Project name  
**BRILL PLACE RESIDENTIAL TOWER**  
Brill Place, London

Title  
**Unitized System Facade**  
EWS05 - Staircase stick system  
Vertical details

Status Drawing No. \_\_\_\_\_ Revision No. \_\_\_\_\_  
**0182-1540-01 01**  
DIVULGATION AND REPRODUCTION FORBIDDEN BY LAW

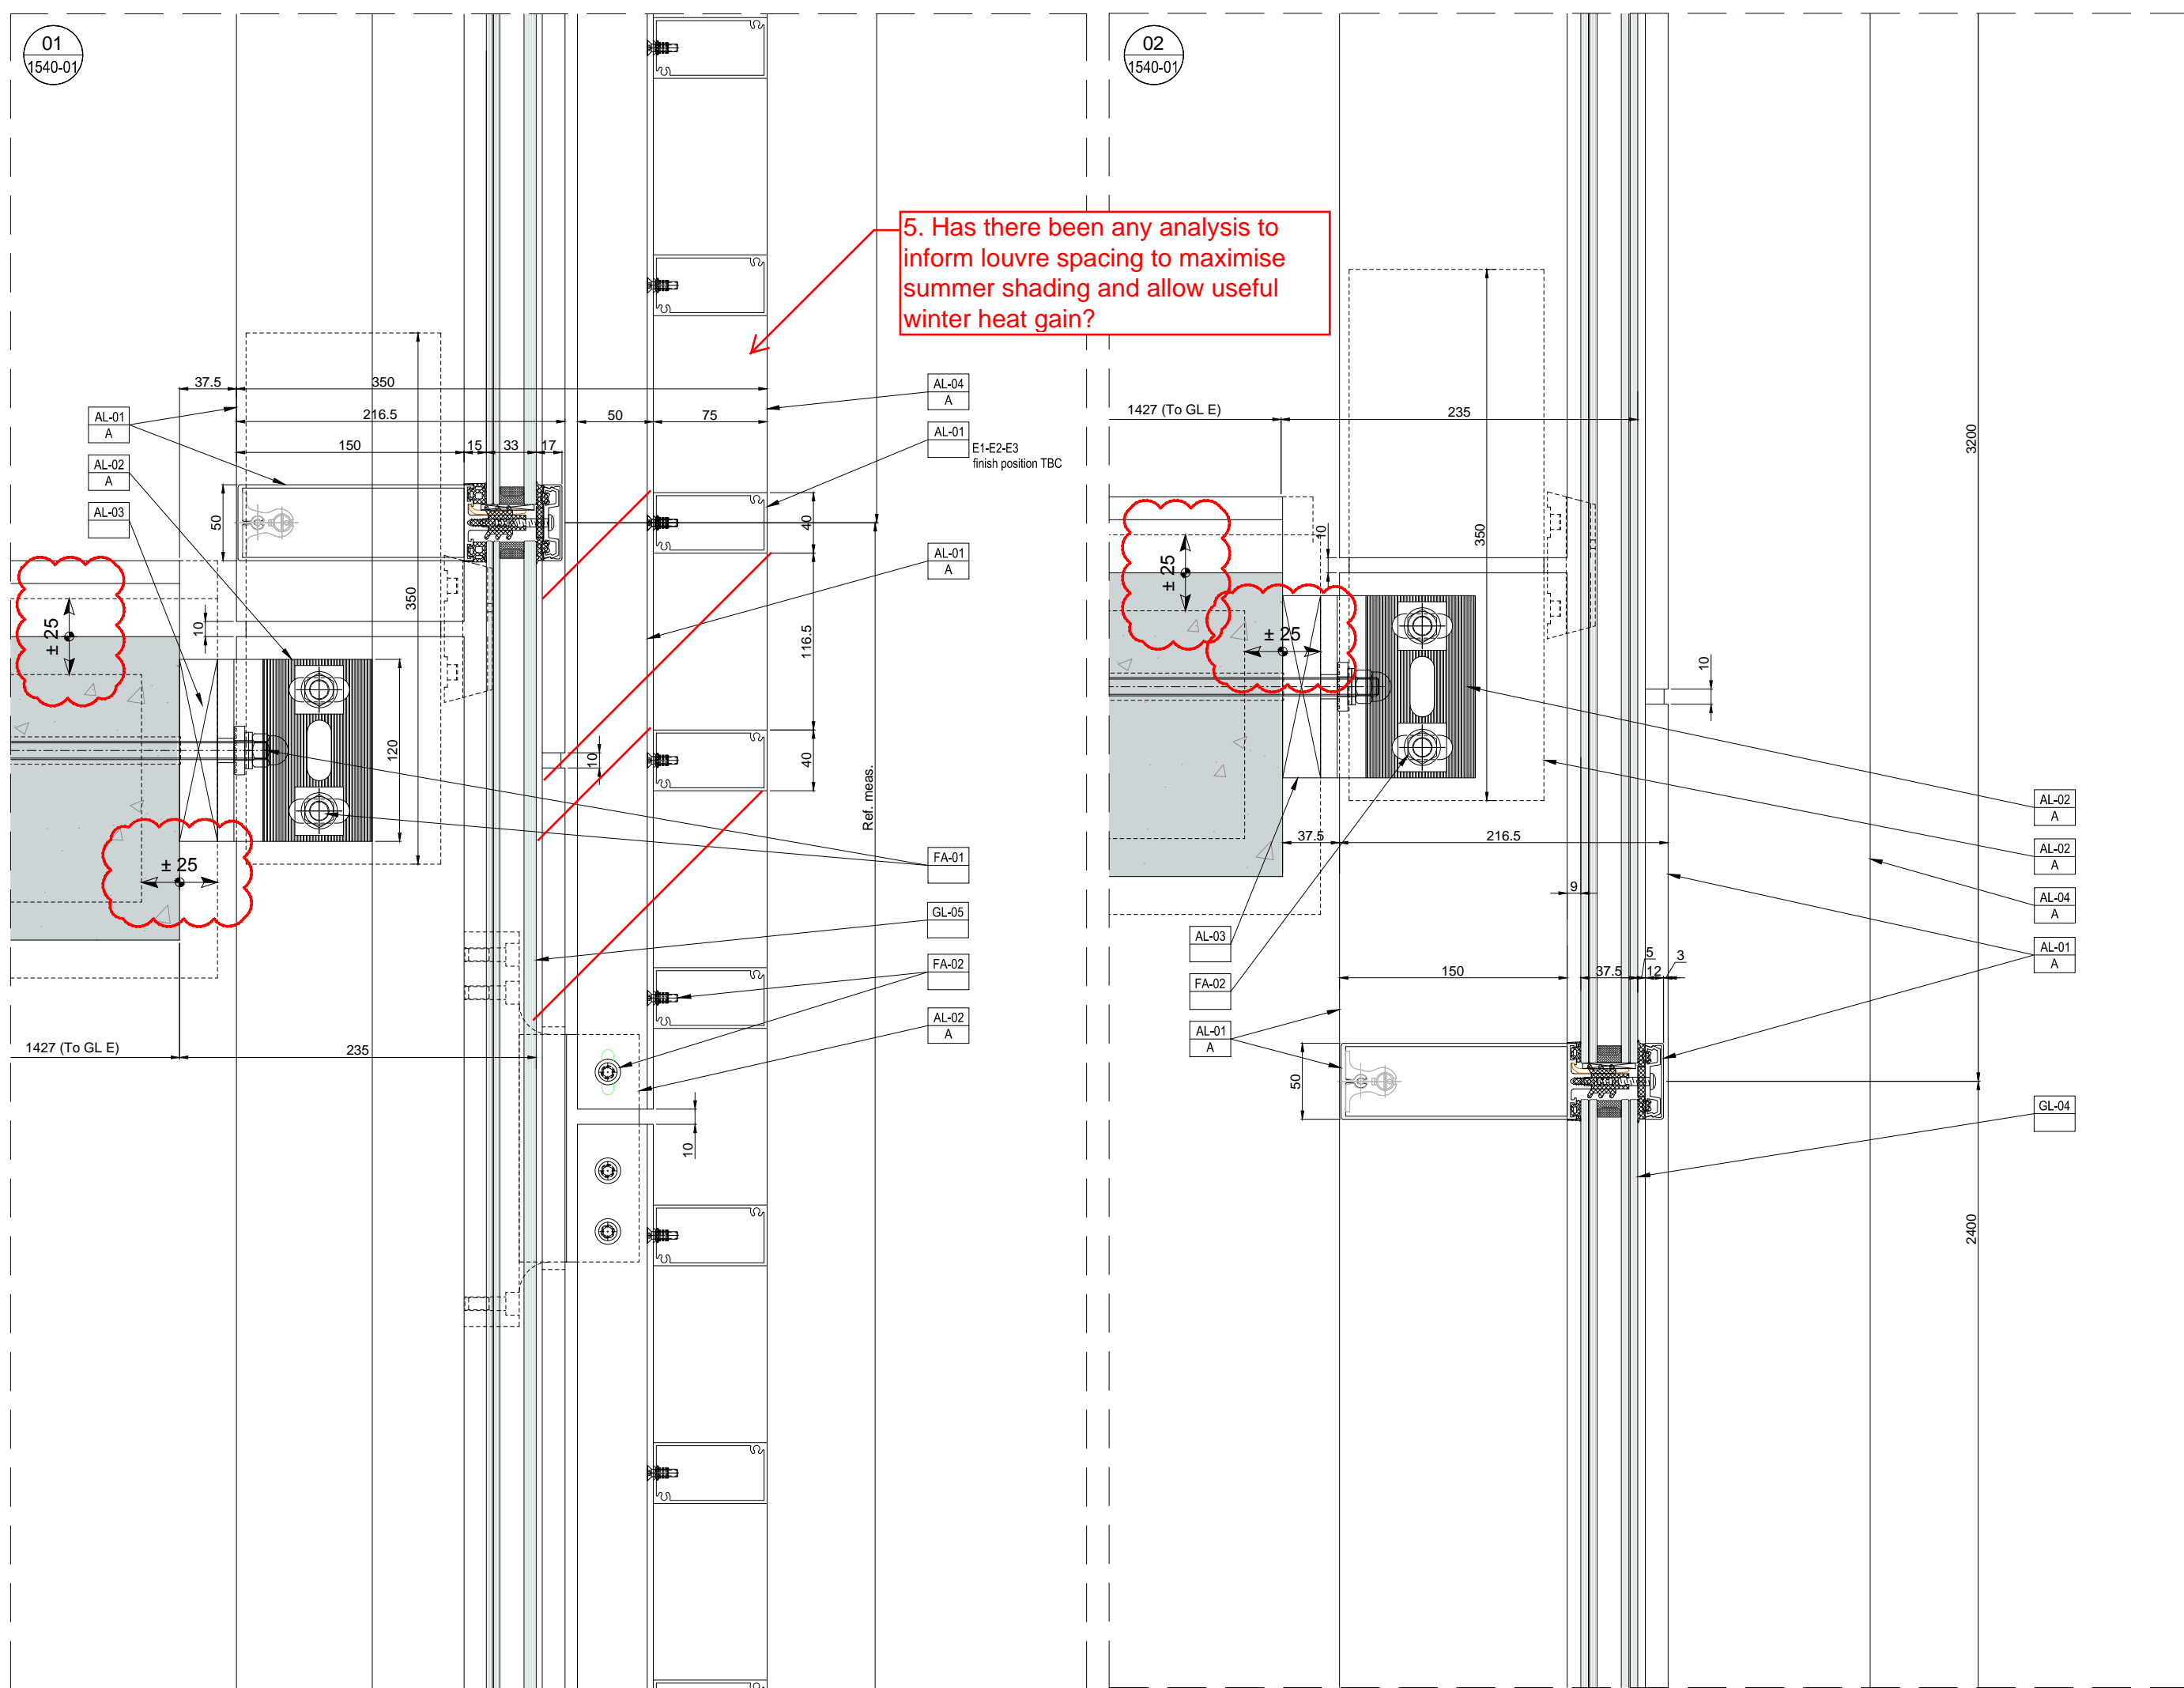
5. Has there been any analysis to inform louvre spacing to maximise summer shading and allow useful winter heat gain?
